Addendum No. 1
Four Rivers Sanitation Authority
Maintenance Building Renovation
Capital Project No. 2102

This Addendum Number 1, dated July 17, 2026, for the above-referenced project, supersedes all contrary and conflicting information in the specifications and contract documents, which are hereby supplemented or revised as follows:

Ref. North
Sheet No. A201
PROFESSIONAL DESIGN FIRM REGISTRATION # 184-003342

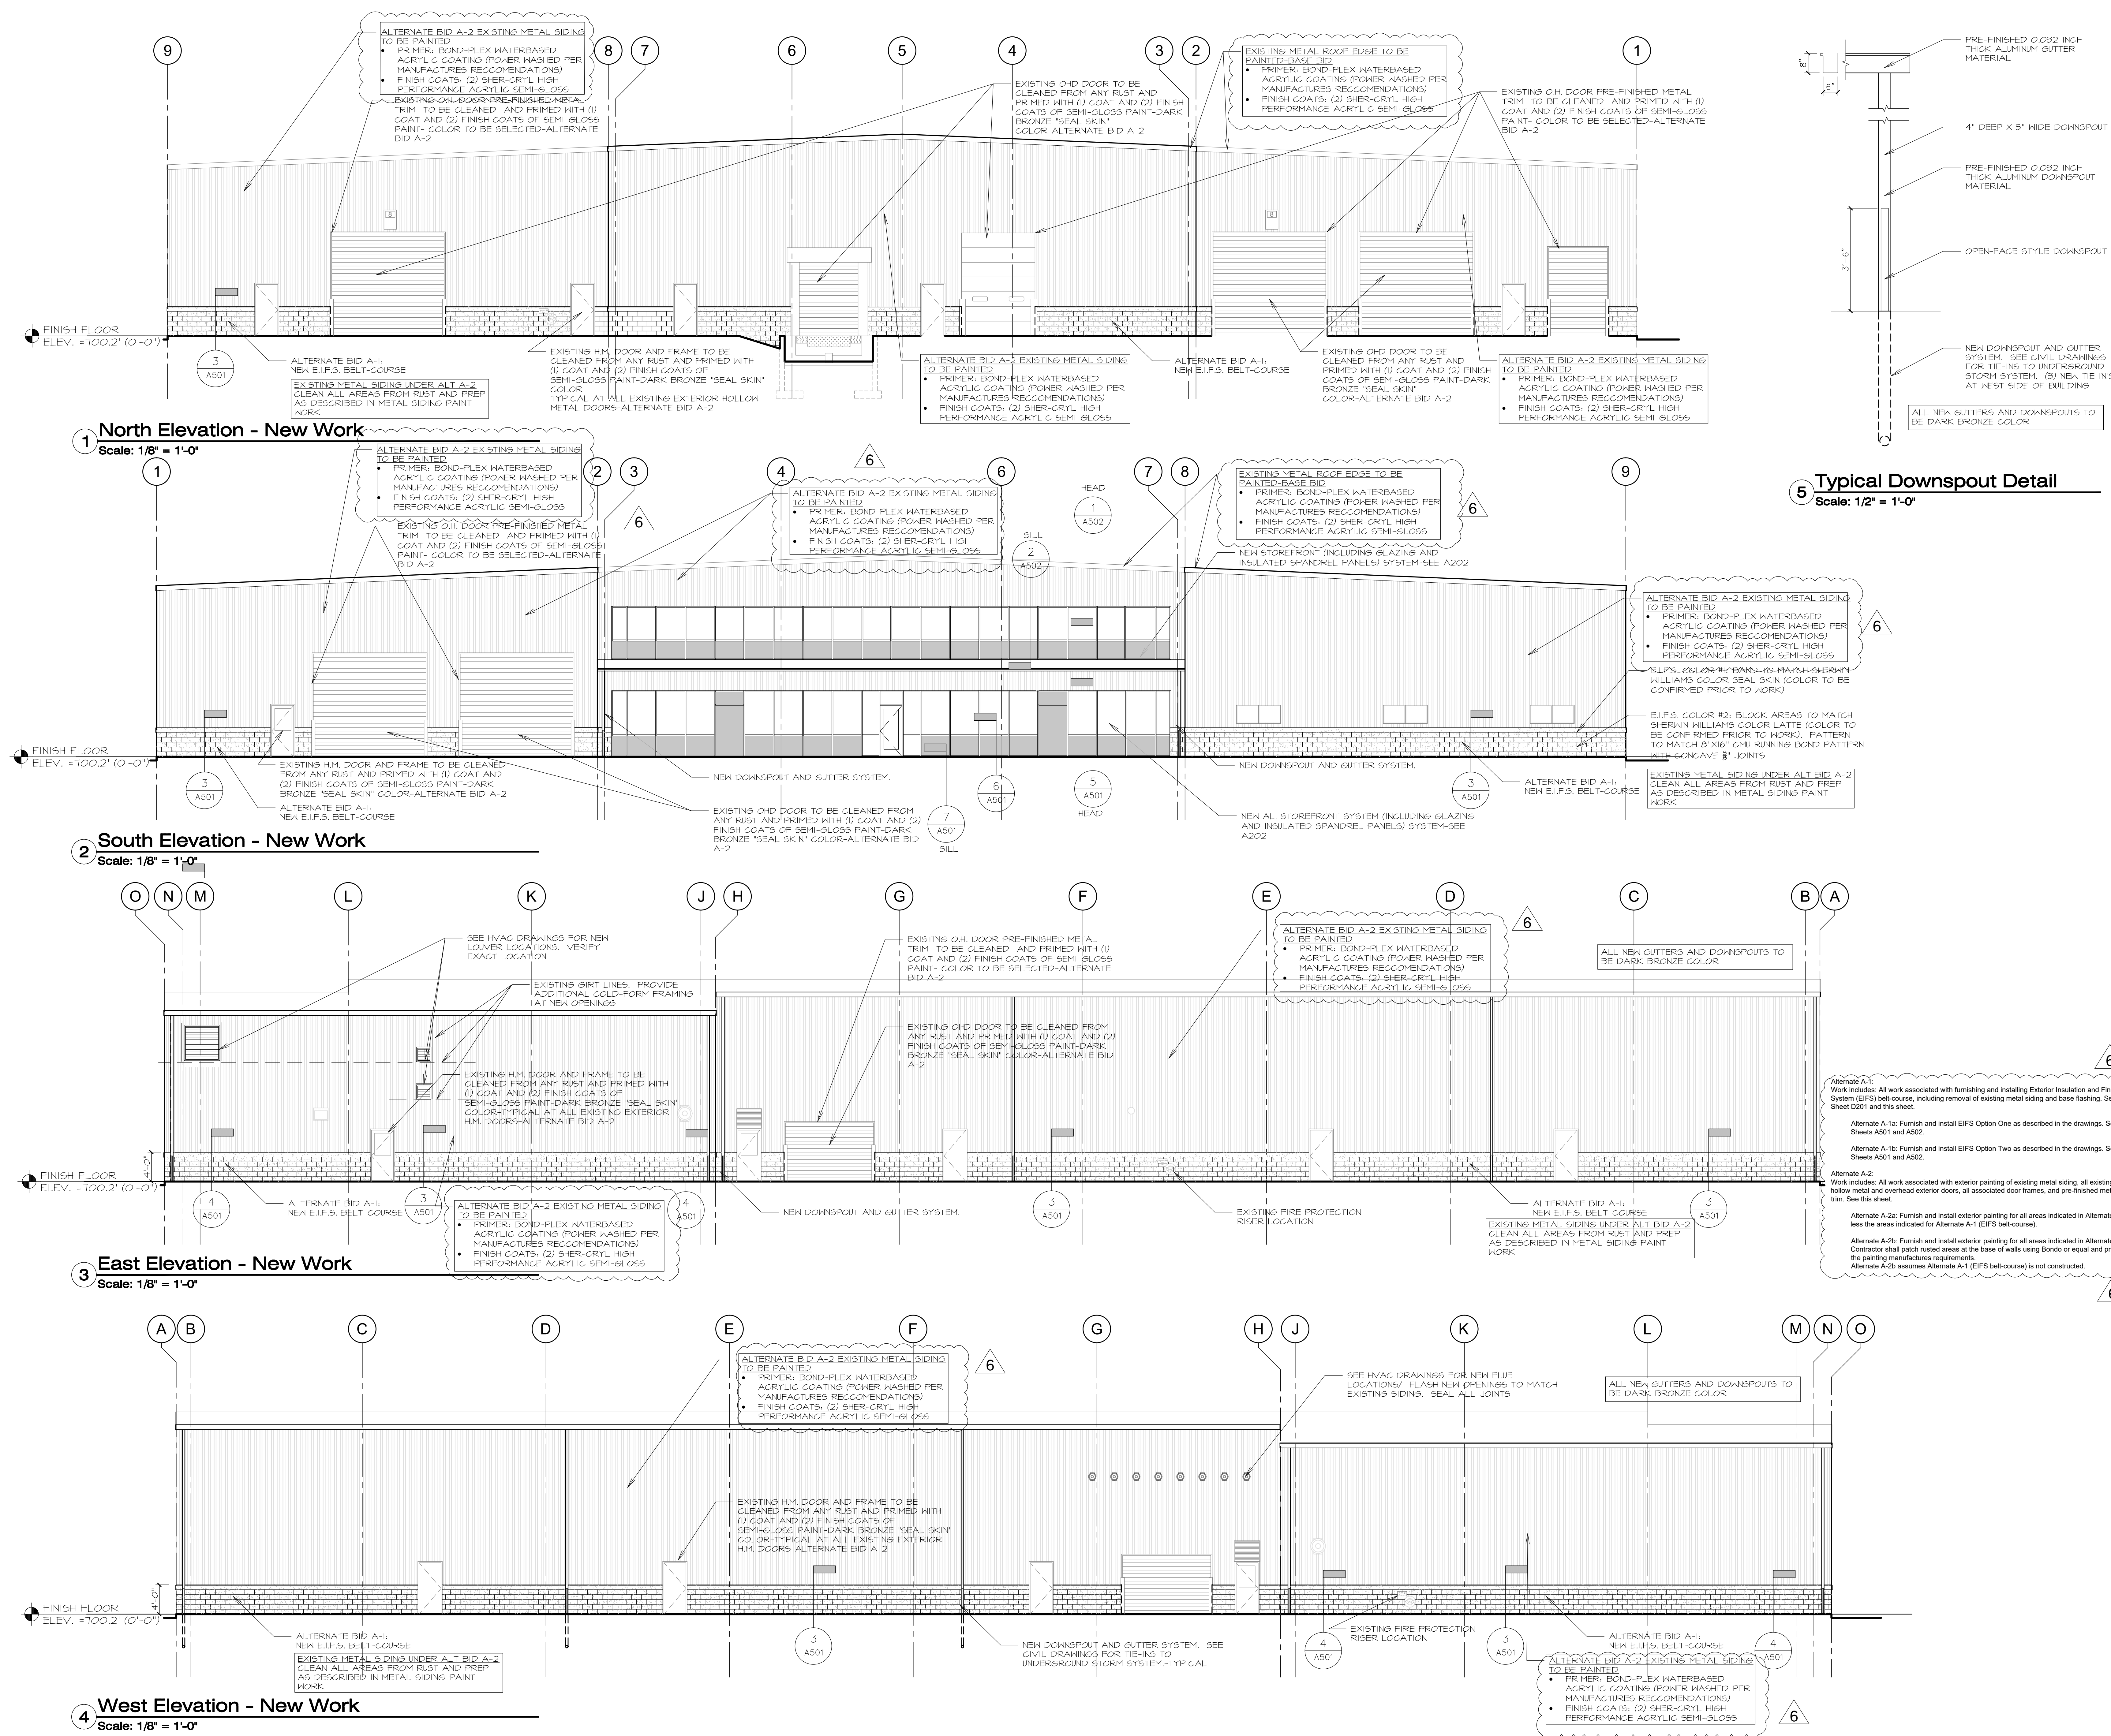
Plan Sheet A201 Exterior Building Elevations: DELETE Sheet A201 in its entirety and REPLACE with the attached revised sheet which clarifies Alternates and provides updated painting specifications.

Q: The specified paint, with epoxy primer and polyurethane gloss finish coat is the wrong product for the application. Can the paint be changed to an acrylic-based product?

A: The paint specifications were changed to an acrylic primer and semi-gloss acrylic finish coat as part of Addendum No.1. See updated Sheet A201.

REFLECTED CEILING PLAN
FIRST FLOOR

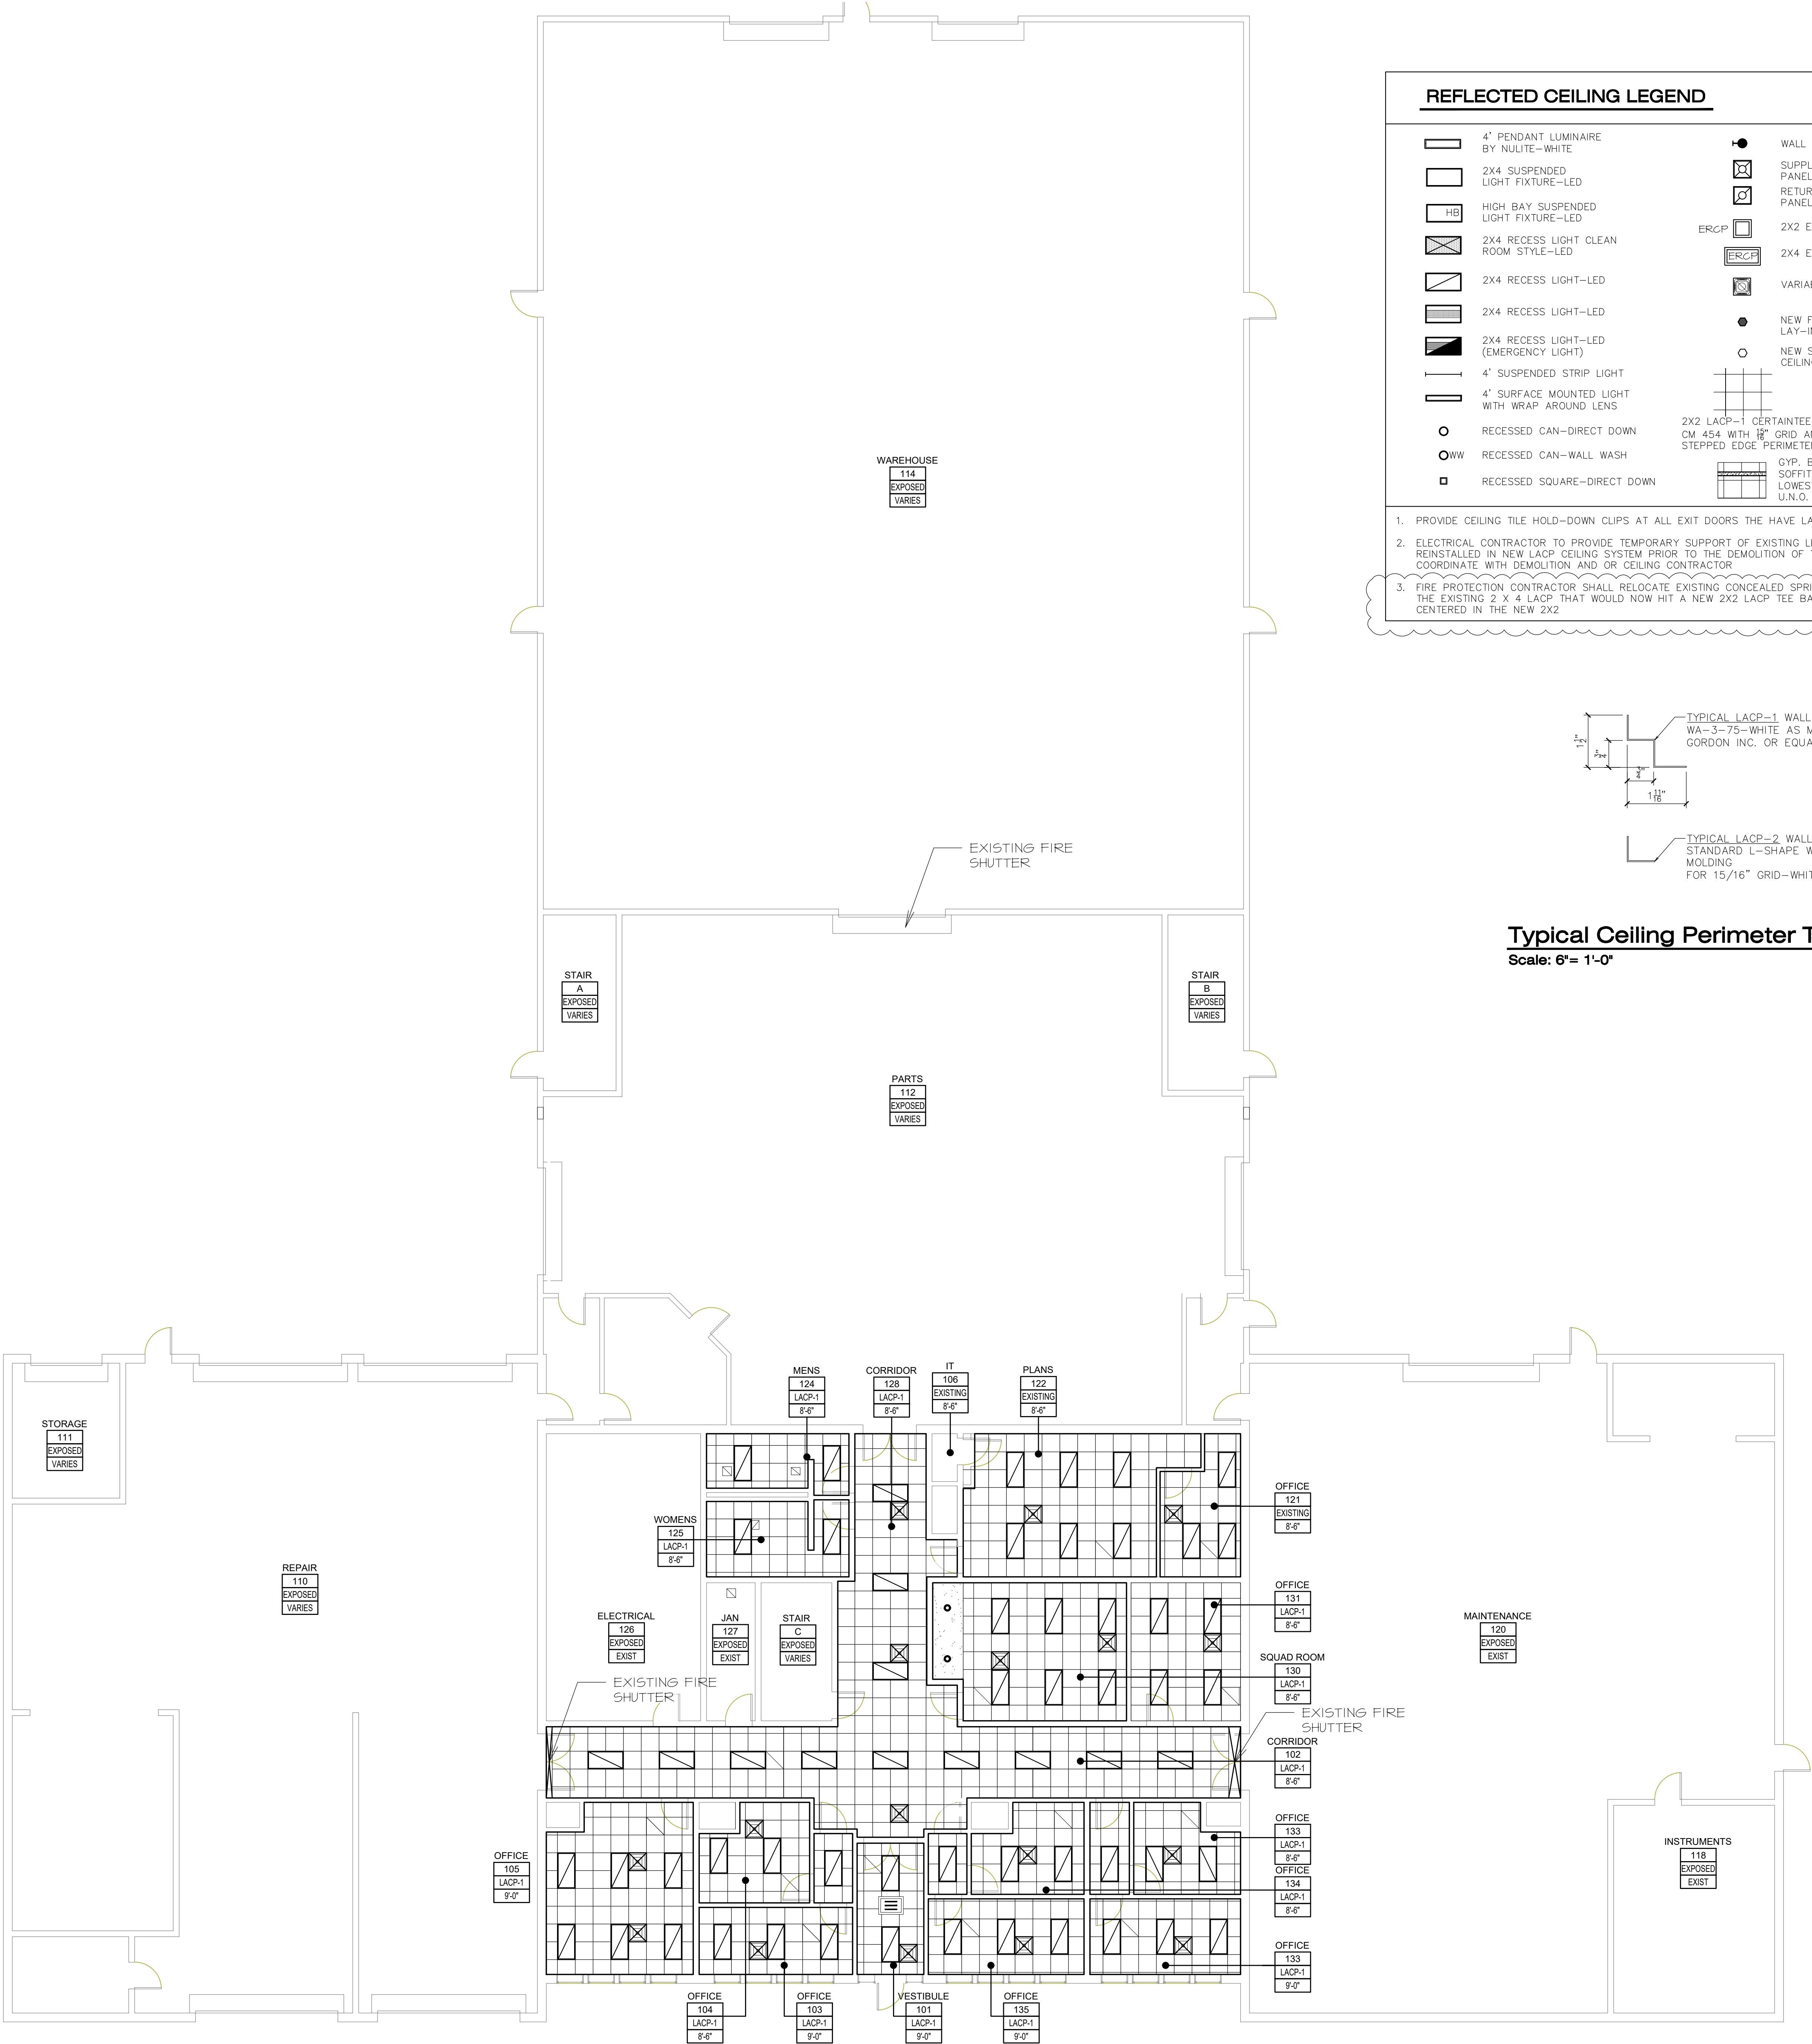
Plan Sheet A401 Reflected Ceiling Plan First Floor: DELETE Sheet A401 in its entirety and REPLACE with the attached revised sheet which notes requirements for relocating existing concealed sprinkler heads.

3. FIRE PROTECTION CONTRACTOR SHALL RELOCATE EXISTING CONCEALED SPRINKLER HEADS THAT WERE CENTERED IN THE EXISTING 2 X 4 LACP THAT WOULD NOW HIT A NEW 2X2 LACP TEE BAR GRID SO THE EXISTING HEAD WILL BE CENTERED IN THE NEW 2X2
